ENGINEER'S TCL CERTIFICATION FOR TEMPORARY CERTIFICATE OF OCCUPANCY

SITE PLAN / TRAFFIC CIRCULATION LAYOUT (TCL)
ALBUQUERQUE SAFE CO.

PAVING SECTIONS AND DETAILS
ALBUQUERQUE SAFE CO.

ENGINEER'S GRADING CERTIFICATION

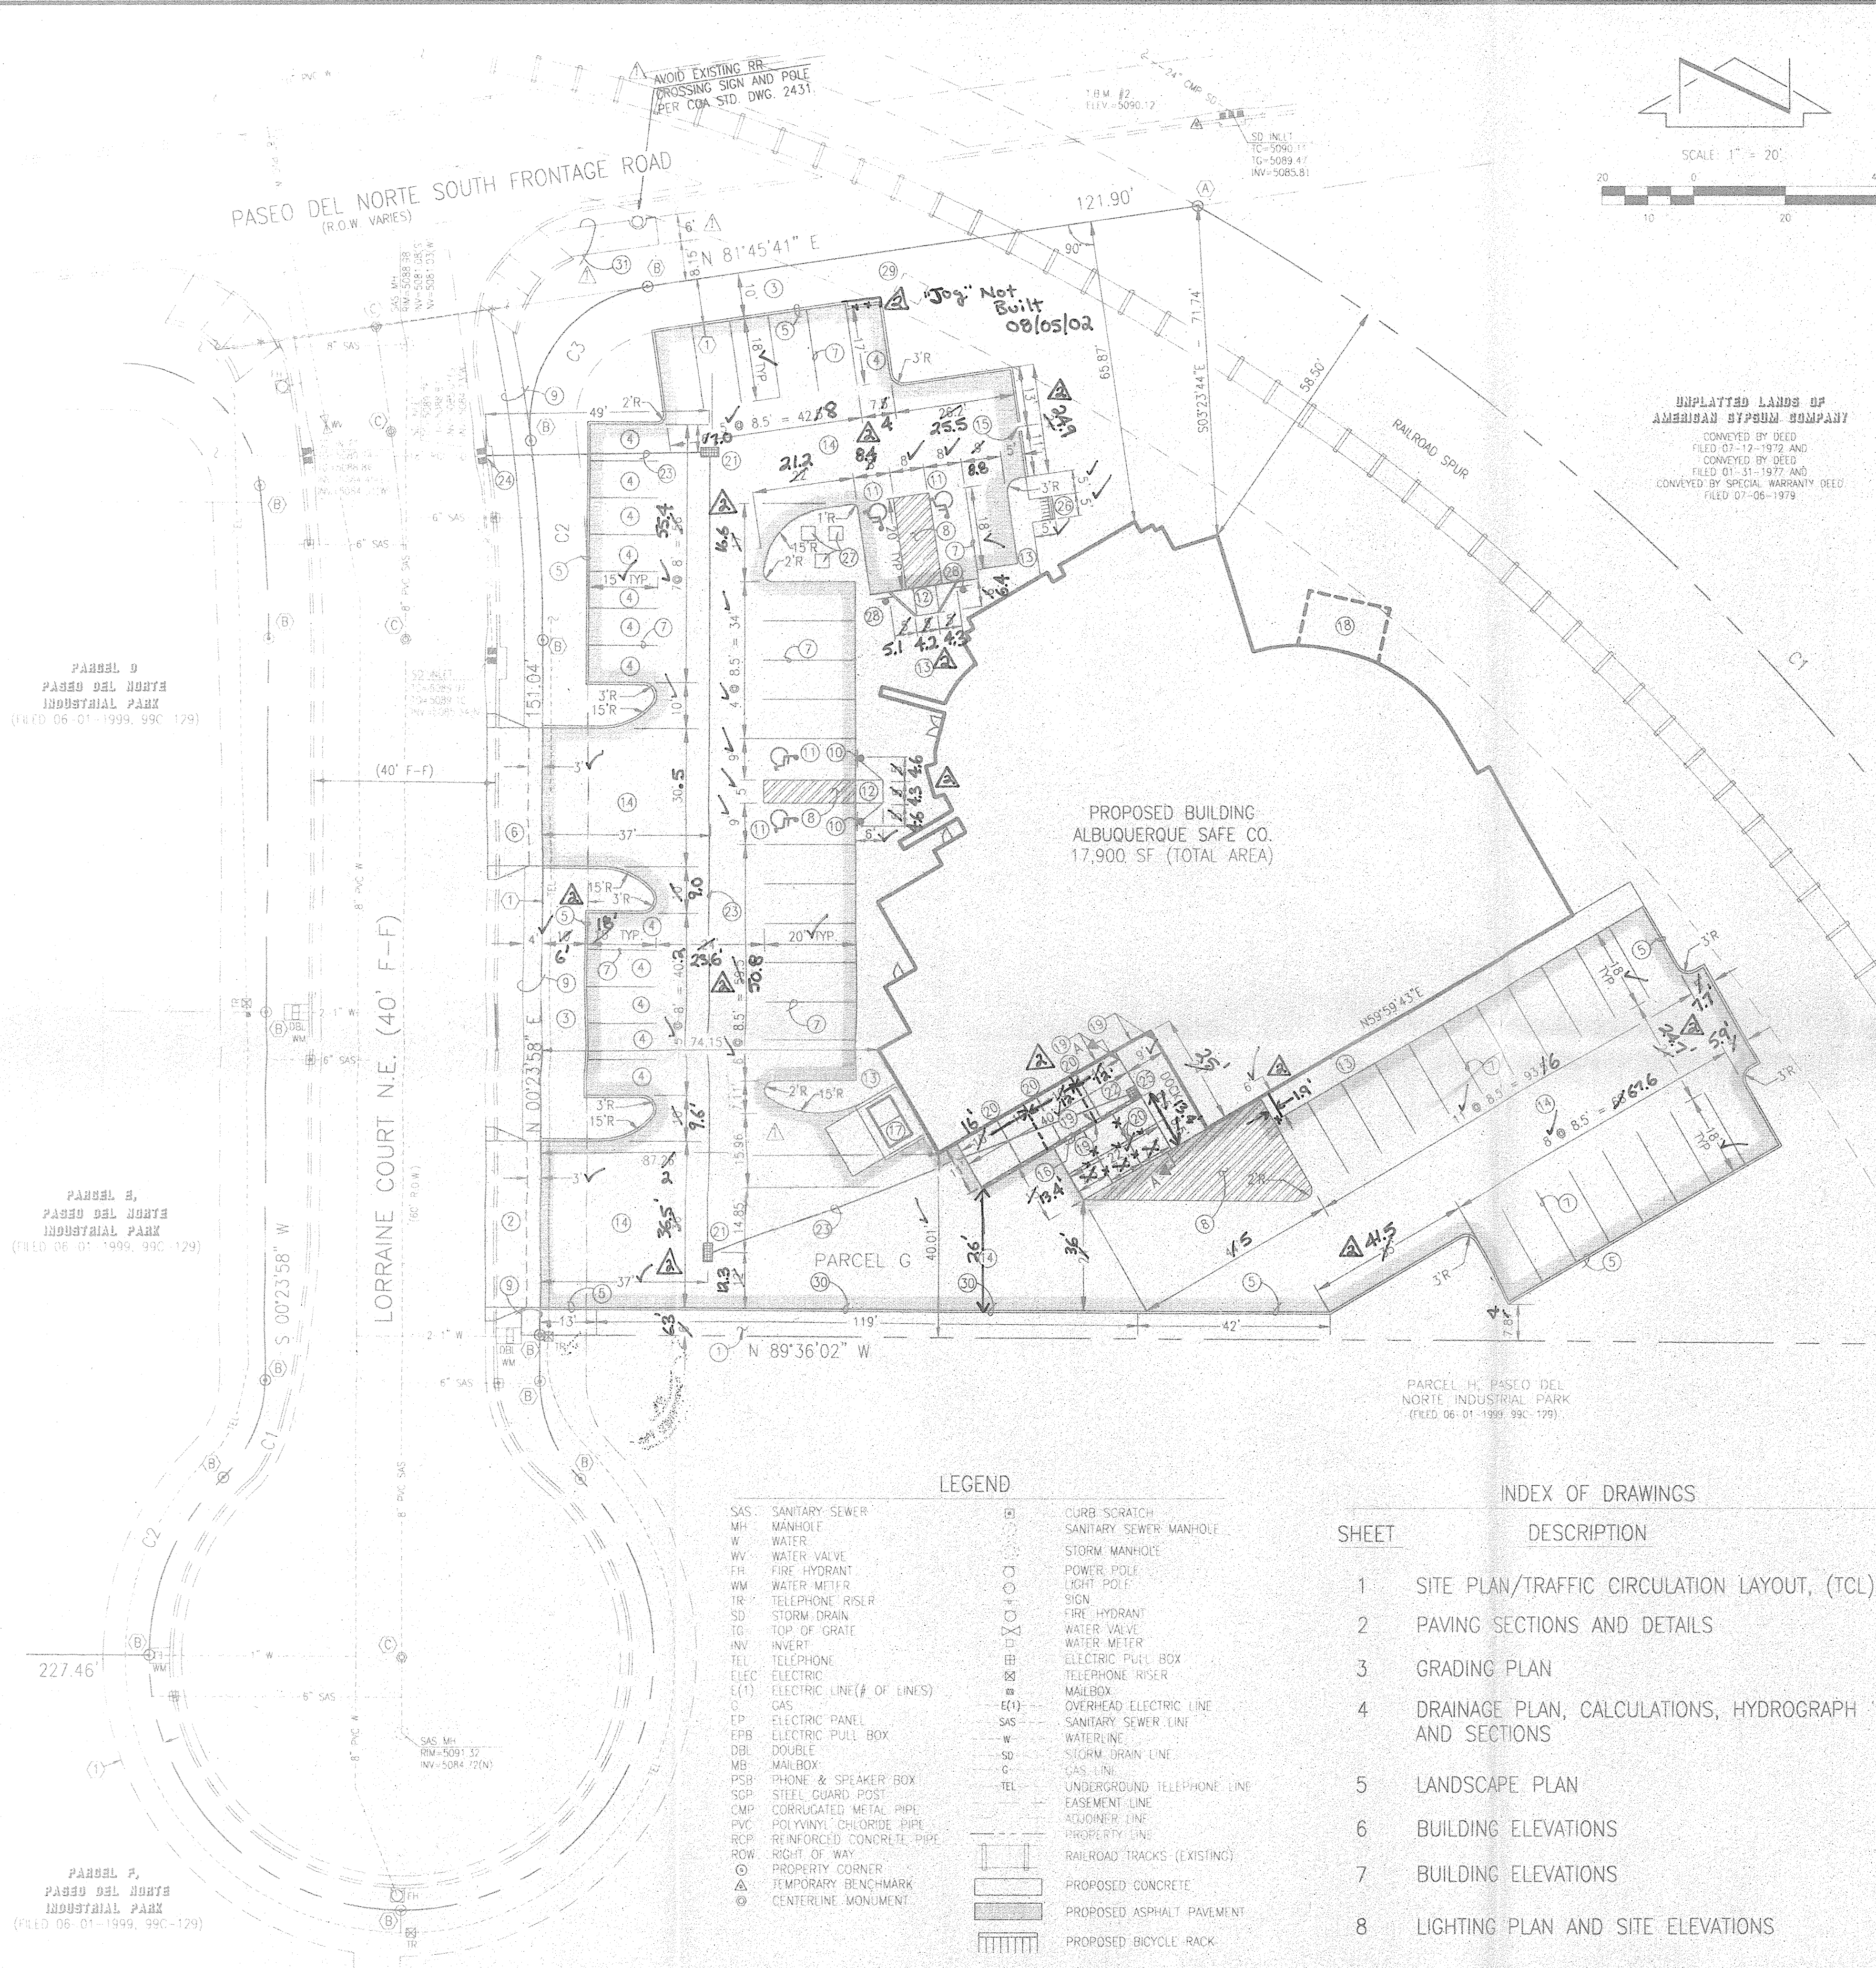
- 1) THE CONTRACTOR DID NOT CONSTRUCT THE "JOG" IN THE CURB AT THE NORTHEAST CORNER OF THE PARKING LOT. THIS JOG WAS INTENDED TO AVOID A POTENTIAL ENCROACHMENT INTO THE EXISTING RAIL SPUR EASEMENT. THIS DEVIATION HAS NO ADVERSE EFFECT ON TRAFFIC CIRCULATION AND EVALUATION OF THIS POTENTIAL ENCROACHMENT IS BEYOND THE SCOPE OF THIS CERTIFICATION.

- 2) THE CONTRACTOR DID NOT CONSTRUCT THE 2'-0" CURB OPENING (KEYED NOTE 15) AT THE EAST END OF THE DRIVE AISLE KEYWAY NORTH OF THE BUILDING. THIS DEVIATION HAS NO ADVERSE EFFECT ON TRAFFIC CIRCULATION, AND WILL BE ADDRESSED BY THE GRADING AND DRAINAGE CERTIFICATION TO BE PREPARED BY THIS OFFICE.

- 3) THE CONTRACTOR DID NOT CONSTRUCT THE CONCRETE HEADER CURB (KEYED NOTE 30) ALONG THE SOUTHERN EDGE OF THE SITE AND INSTALLED EXTRUDED CURB IN ITS PLACE. THIS DEVIATION HAS NO ADVERSE EFFECT ON TRAFFIC CIRCULATION, AND WILL BE ADDRESSED BY THE GRADING AND DRAINAGE CERTIFICATION TO BE PREPARED BY THIS OFFICE.

- 4) THE 6" PRIVATE STORM DRAIN LINES WERE SPECIFIED AS DUCTILE IRON PIPE AND WERE CONSTRUCTED AS PVC. THIS DEVIATION HAS NO ADVERSE EFFECT ON TRAFFIC CIRCULATION, BUT THE OWNER MAY EXPERIENCE ADDITIONAL MAINTENANCE AND A REDUCED LIFE CYCLE FOR THE PIPE DUE TO THE ANTICIPATED REPEATED HEAVY TRUCK LOADS.

- 1) THE CONTRACTOR DID NOT CONSTRUCT THE PIECE OF 6' WIDE CONCRETE SIDEWALK FRONTING EL PUEBLO ROAD (KEYED NOTE 31). THIS SIDEWALK MUST BE CONSTRUCTED IN ACCORDANCE WITH THE DRB APPROVED PLAN.

- 2) THE CONTRACTOR DID NOT INSTALL THE "SMALL CAR" STENCILING (KEYED NOTE 4) IN THE SMALL CAR SPACES. THESE MARKINGS MUST BE INSTALLED IN ACCORDANCE WITH THE DRB APPROVED PLAN.

- 3) THE CONTRACTOR CONSTRUCTED THE SMALL CAR PARKING SPACES BETWEEN THE TWO DRIVEPADS 18' DEEP INSTEAD OF 15' DEEP AS SHOWN ON THE DRB APPROVED PLAN. THIS DEVIATION RESULTS IN PARKING SPACES WITH FULL SIZED DEPTH AND SMALL CAR WIDTH AND MUST BE CORRECTED TO CONFORM WITH THE DRB APPROVED PLAN. THE ADDITIONAL PARKING SPACE DEPTH PROVIDED SUBTRACTS FROM THE LANDSCAPING BUFFER DEPTH WHICH WAS SPECIFIED AS 10' AND CONSTRUCTED AS 6'. POTENTIALLY CAUSING A ZONING VIOLATION.

- 4) THE CONTRACTOR HAS CONSTRUCTED THE ACCESSIBLE PARKING SPACES NORTH AND WEST OF THE BUILDING AT SLOPES VARYING BETWEEN 2.9% AND 4% WHICH EXCEED THE MAXIMUM 2% SLOPE IDENTIFIED IN A.D.A. GUIDELINES AND SPECIFIED ON THE DRB APPROVED PLAN. THESE SPACES MUST BE CORRECTED TO CONFORM WITH A.D.A. GUIDELINES.

- CONSTRUCT 6" TURNDOWN SIDEWALK PER TYPICAL SECTION, SHEET 2
- CONSTRUCT NEW ASPHALT PAVING PER TYPICAL PAVEMENT SECTION, SHEET 2
- 2' 0" CURB OPENING Not Built 08/05/2002

Not Built 08/05/2002
